Request 13

Furnish Ford's assessment of the following vehicle conditions, including:

Figure 3: Hydroboost System Components – 2021 – 2022MY E-Series Cutaway

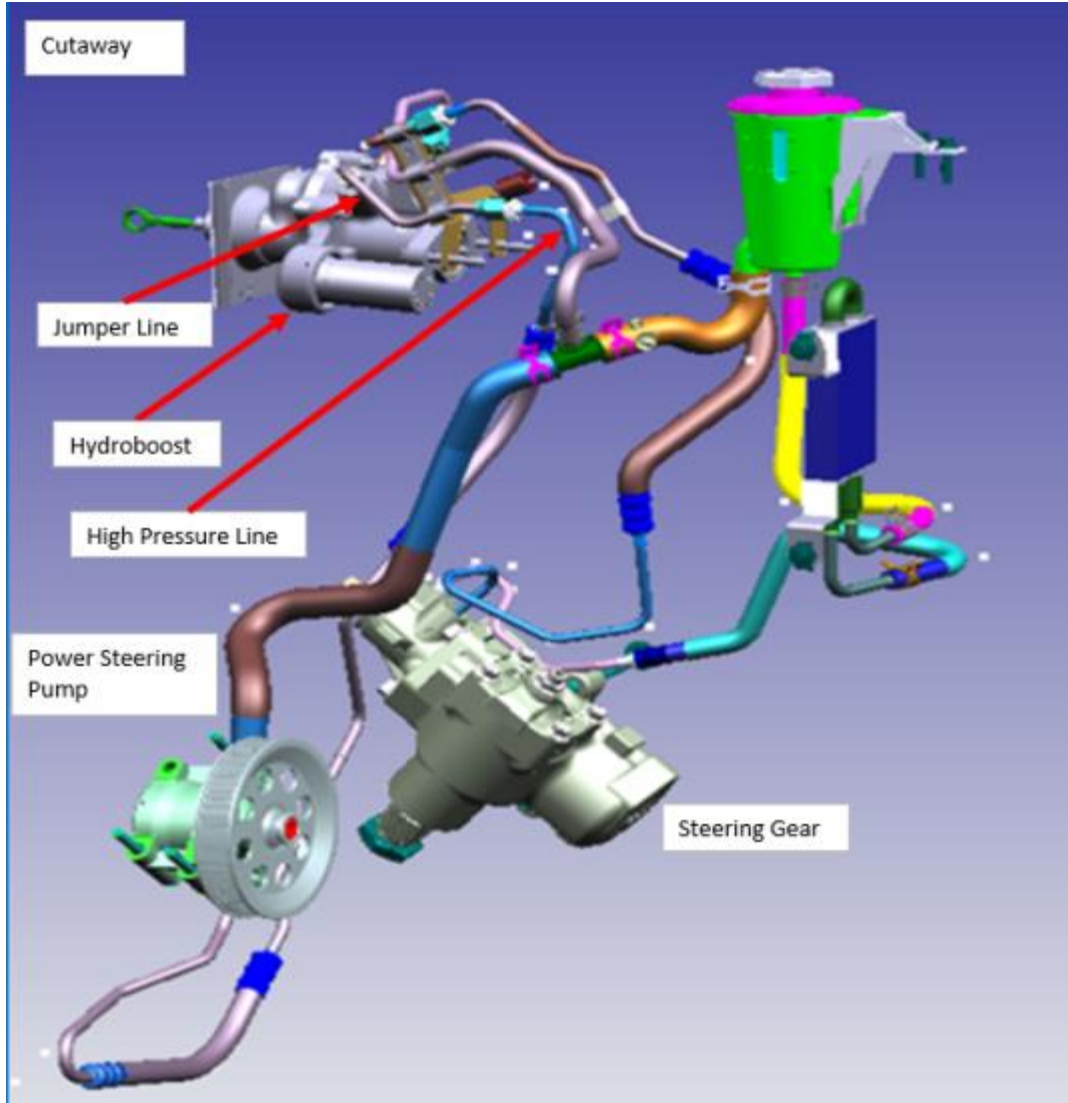
- a. Provide detail related to differences in vehicle drive options and their effect on failure conditions (two wheel drive vs four wheel drive);
- b. Provide component details, and production dates, if subject vehicles available with more than one option for the following components;
 - i. Power steering pump
 - ii. Steering gear
 - iii. Hydroboost unit
- c. Provide pressure relief detail of the power steering pump;
- d. Provide the amount of brake boost gain in relation to operator pedal application.

Ford does not believe that the type of vehicle, stripped chassis or cutaway, has an effect on failure conditions related to the alleged defect. Both vehicle types use a high-pressure power steering line and a jumper line to enable power steering fluid to flow from the power steering pump to the power brake assist booster. The high-pressure power steering line is unique between the stripped chassis and cutaway vehicle type. However, the jumper line and quick-connect fitting used to connect the jumper line and the high-pressure power steering line is common between the vehicle types.
